Service Letter No. 412A (Supersedes No. 412)

SUBJECT: Muffler and Tailpipe Support

MODELS AFFECTED: PA-24 "250" Comanches only, Serial Nos. 24-2175, 24-2299 to 24-3321 incl., 24-3323 to 24-3394 incl., 24-3396 to 24-3437 incl., 24-3439 to 24-3441 incl., 24-3443, 24-3444, 24-3446 to 24-3457 incl., 24-3459, 24-3460, 24-3462 to 24-3464 incl., 24-3466 to 24-3484 incl., 24-3488 to 24-3536 incl., 24-3538 to 24-3549 incl., 24-3551 to 24-3557 incl.

Service Letter 412A

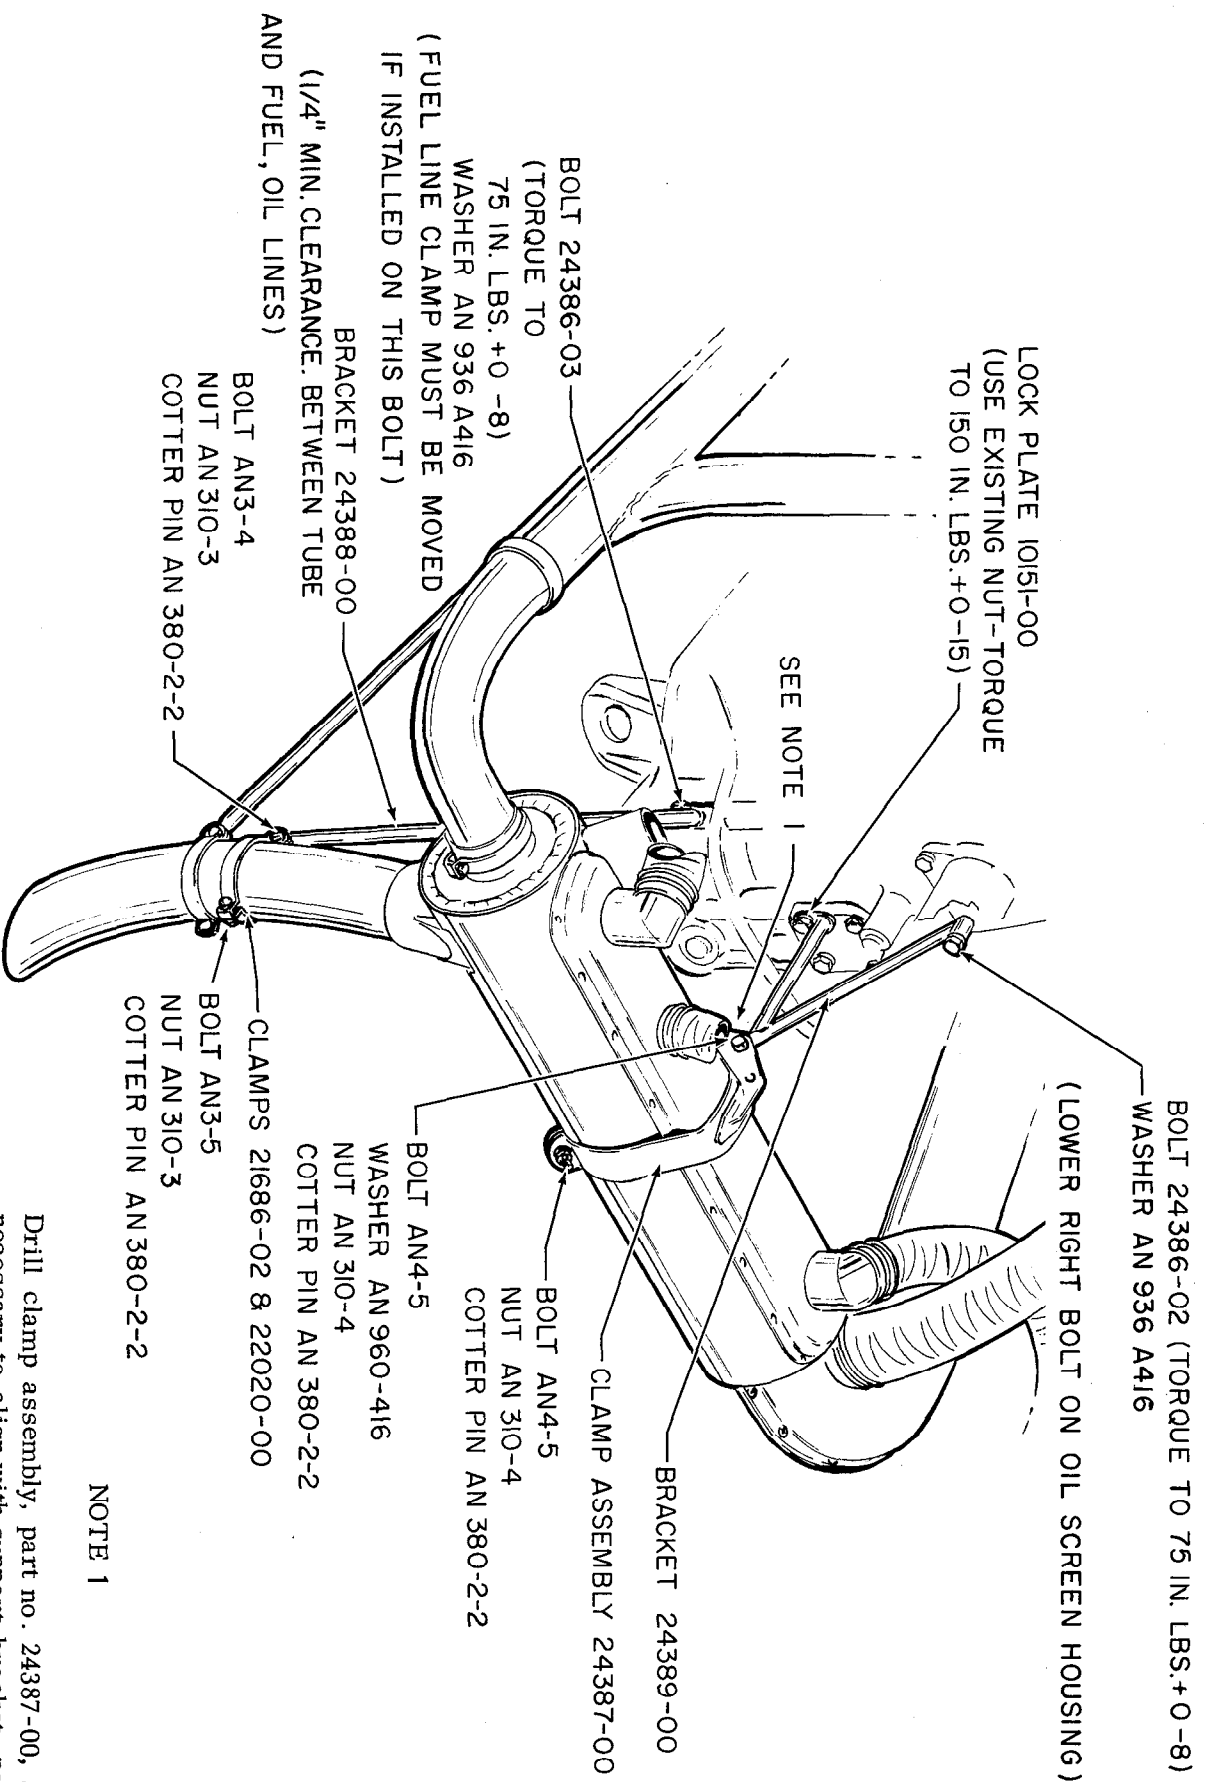
This Service Letter is to advise that a muffler support bracket and a bracket to support the tailpipe are available for installation on the subject aircraft.

These supports are applicable to the PA-24 "250" Comanches within the serial numbers listed above and it is recommended that they be installed on these aircraft as the additional support will be instrumental in extending the service life of the exhaust system.

NOTE 1

Drill clamp assembly, part no. 24387-00, as necessary to align with support bracket, part no. 24309-00. Disregard the two tooling holes in the clamp assembly. (Use .250 drill)
